WATERVIEW EAST PRELIMINARY PLAN

LOCATED IN A PORTION OF SECTION 9, T15S, R65W OF THE 6TH P.M.,
EL PASO COUNTY, STATE OF COLORADO

Computer File Information	
Creation Date: 2-27-17	Initials: CMD
Last Modification Date: 4-3-17	Initials: BG
Full Path & Drawing File Name: V:\1817\active\181710214\CAD\Plansheets Title Sheet	
Acad Ver. 2014	Scale: see plan Units: Feet

Project No./Code	181710214
Sheet Number	9 of 9

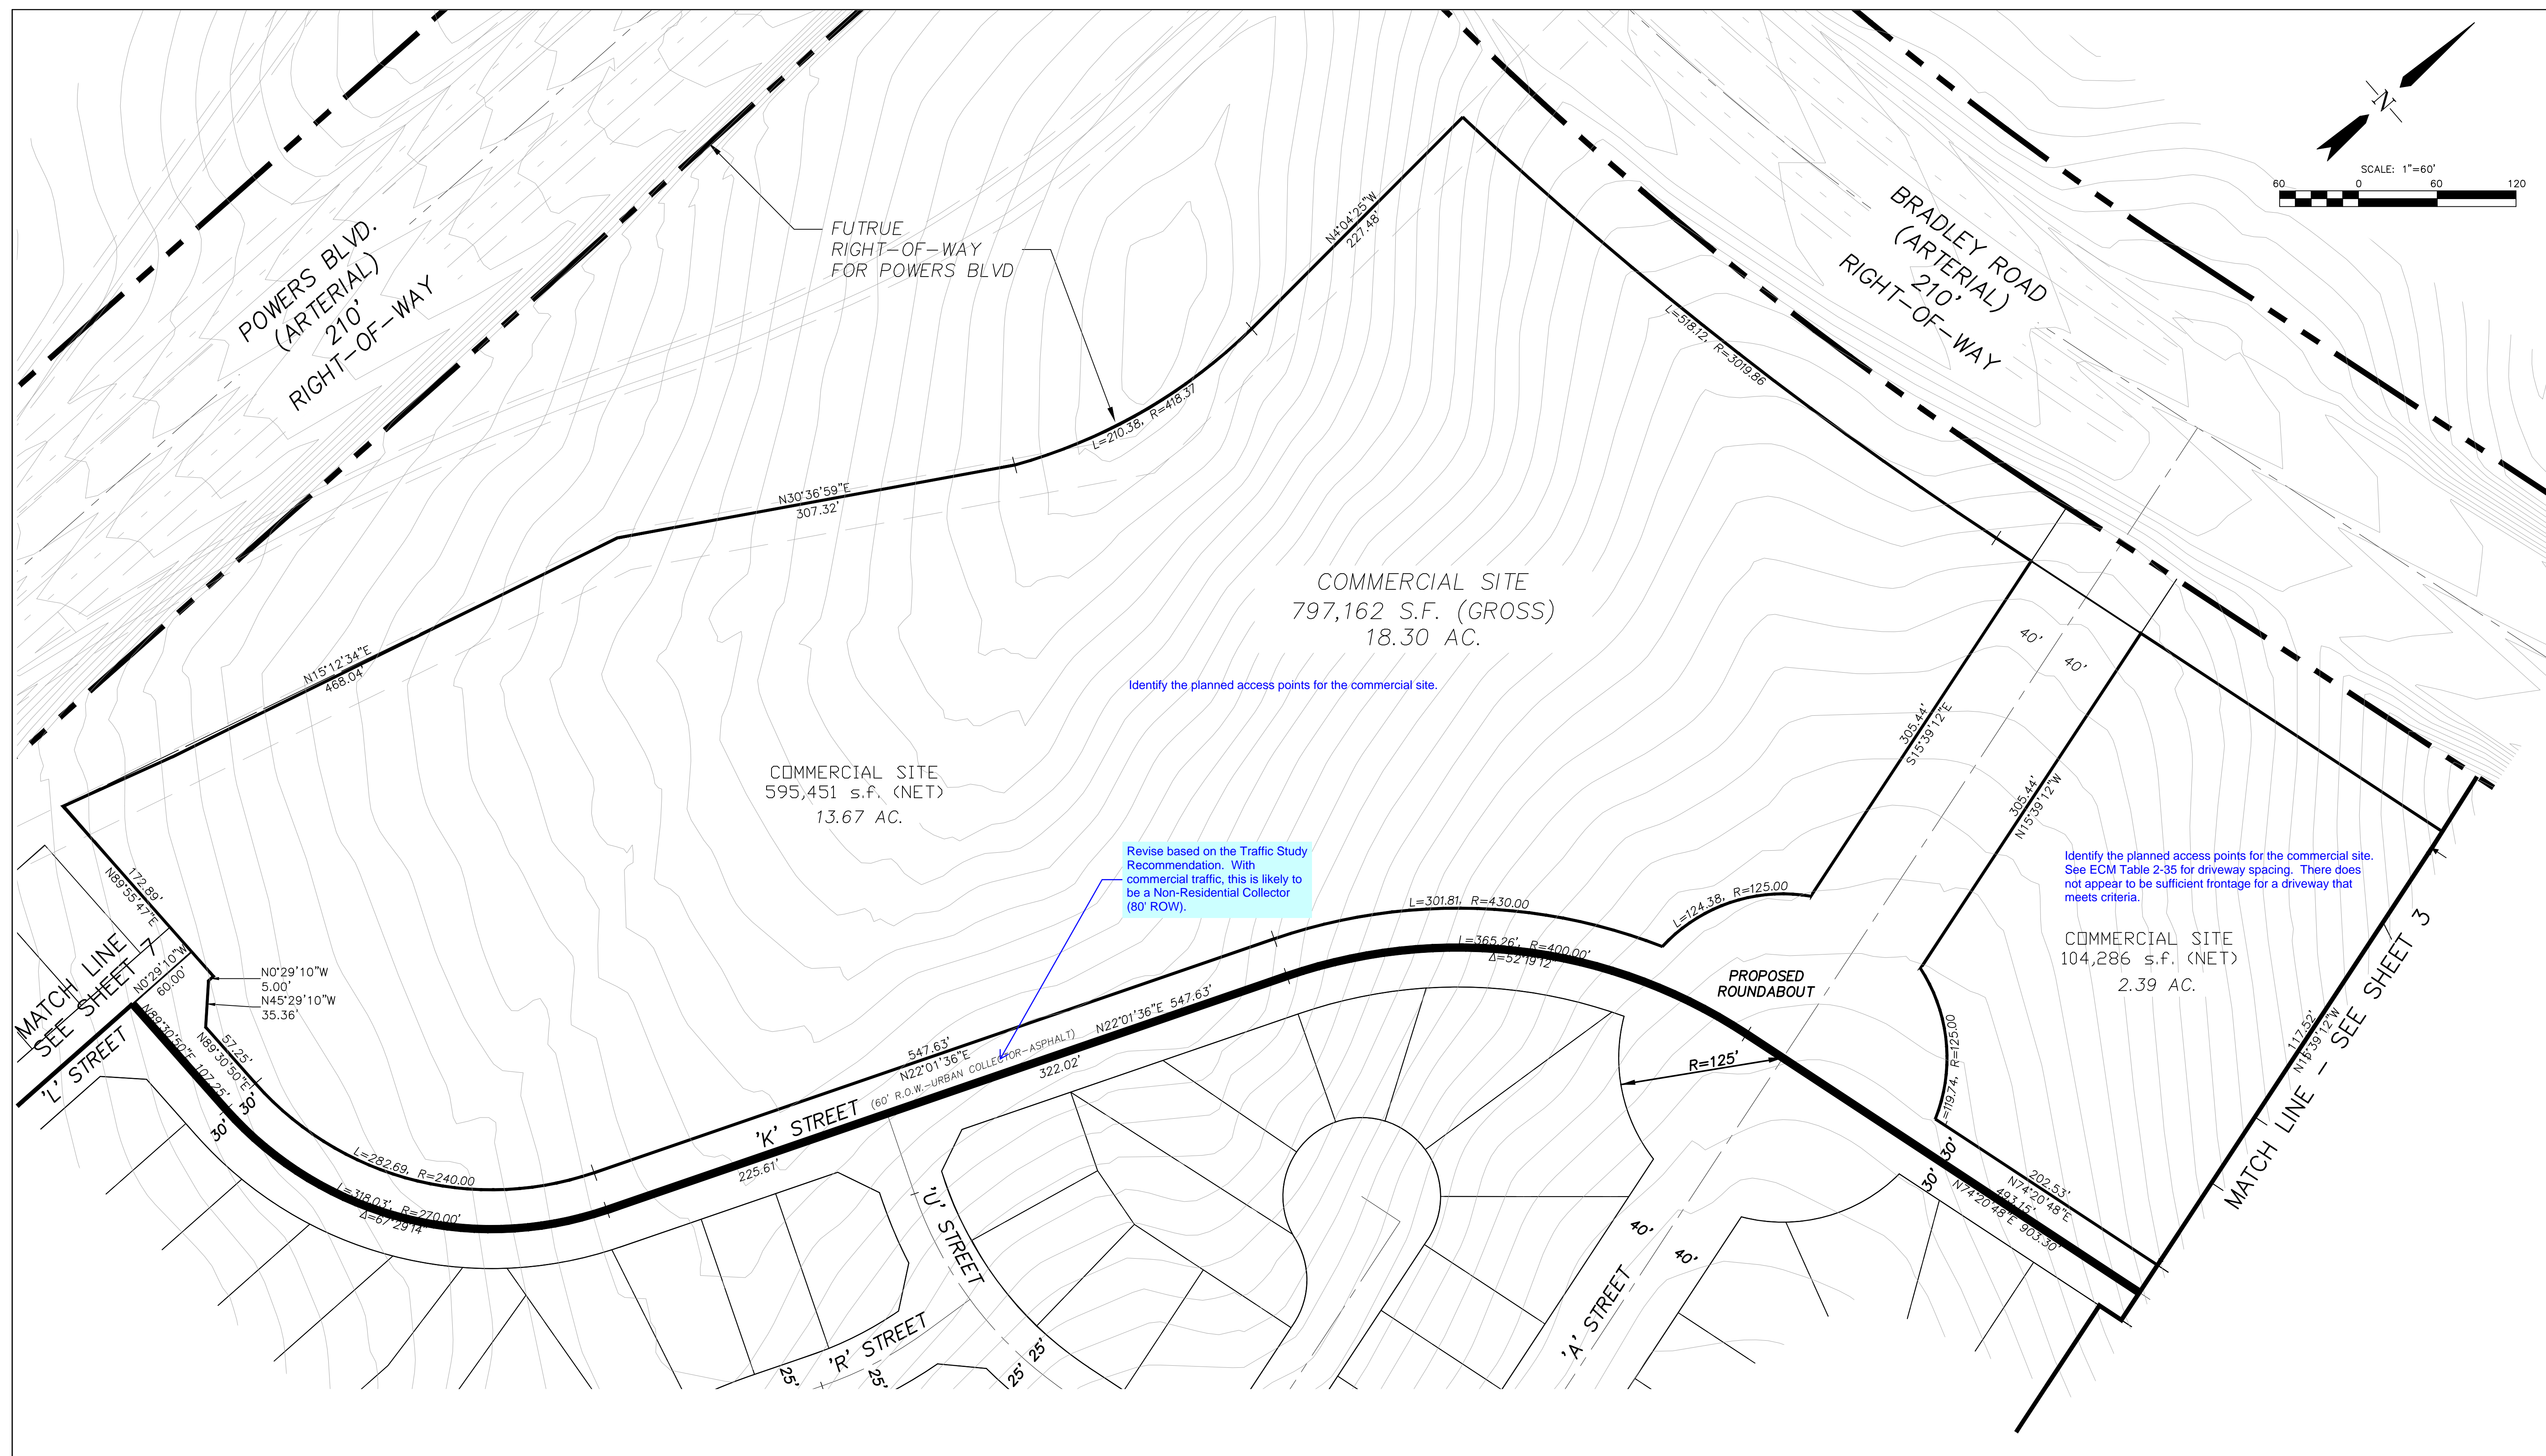
Identify the planned access points for the commercial site.

Revise based on the Traffic Study Recommendation. With commercial traffic, this is likely to be a Non-Residential Collector (80' ROW).

Identify the planned access points for the commercial site.
See ECM Table 2-35 for driveway spacing. There does not appear to be sufficient frontage for a driveway that meets criteria.
